Prepared For: Rosemont Copper Company

By: Water & Earth Technologies, Inc.

Subject: Response to Technical Memorandum dated July 27, 2015 by Dr. Mathias Kondolf and James Ashby

Figure 1. Unit Discharge vs Watershed Area for Sonoita Creek from USGS Regression Equations.

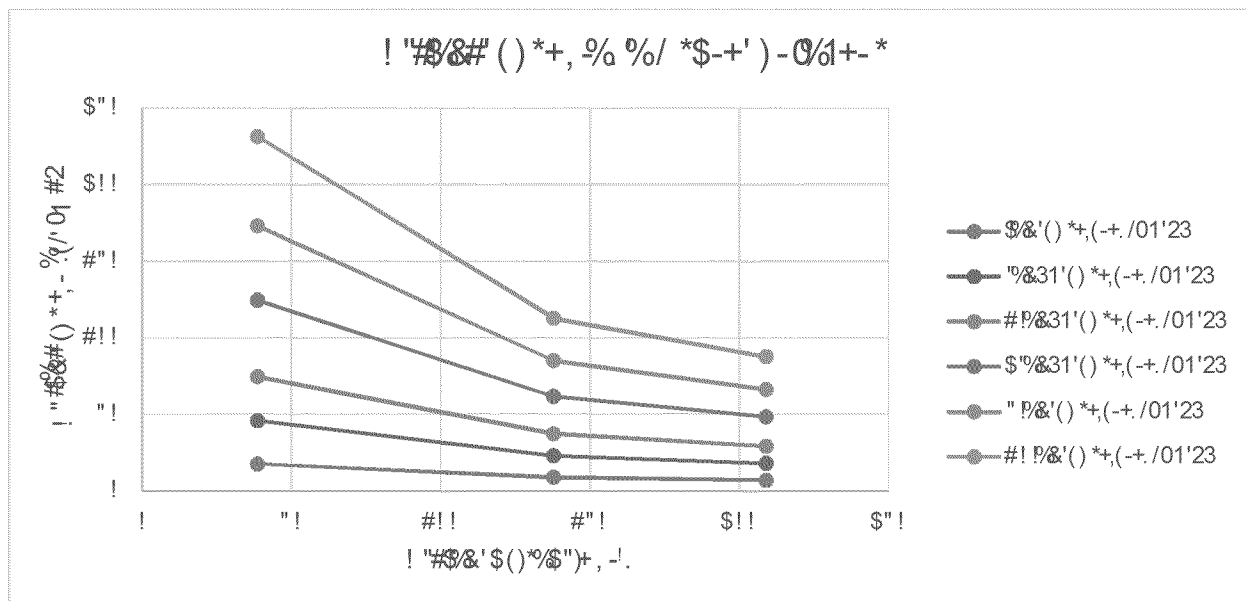
Finding 1: The hydrologic modeling significantly overestimates the water available for Sonoita Creek and the proposed constructed channels.

Kondolf-Ashby state that WET overestimates peak discharge for the project by 2-3 times, but their analysis clearly illustrates that the ratio of peak discharge to watershed area at the project is roughly 2-3 times larger than the ratio of peak discharge to watershed area at the USGS Patagonia gage located about 7 miles downstream of the project, and infer that discharge increases linearly with watershed area. However, literature and hydrologic models demonstrate that discharge does not increase linearly with watershed area for medium to large watersheds (such as this project) in the arid southwest. In fact, a recent EPA technical report (Levick et al., 2008), which was co-authored by Robert Leidy of the EPA, notes this relationship and references several papers that demonstrate the non-linear relationship between discharge and watershed area. The non-linear relationship results from three factors: spatial and temporal variability of monsoonal precipitation, transmission losses, and flow attenuation. Further analysis of this can be done by considering the USGS regional regression equations for estimating discharge in ephemeral streams in Arizona (Paretti et al., 2014). The USGS has subdivided Arizona into 5 flood districts based on their basin characteristics and rainfall-runoff response. Sonoita Creek is located in Flood Region 5. Discharge was calculated with the applicable USGS regional regression equation for the three sites used in the Kondolf-Ashby memo, and then discharge from each site was divided by watershed area to illustrate the non-linear relationship discharge has with watershed area (Table 1 & Figure 1).

Unit discharges from the USGS Regression Equations also demonstrate that the ratio of discharge to watershed area at the project is roughly 2-3 times larger than the ratio of discharge to watershed area at the USGS Patagonia Gage.
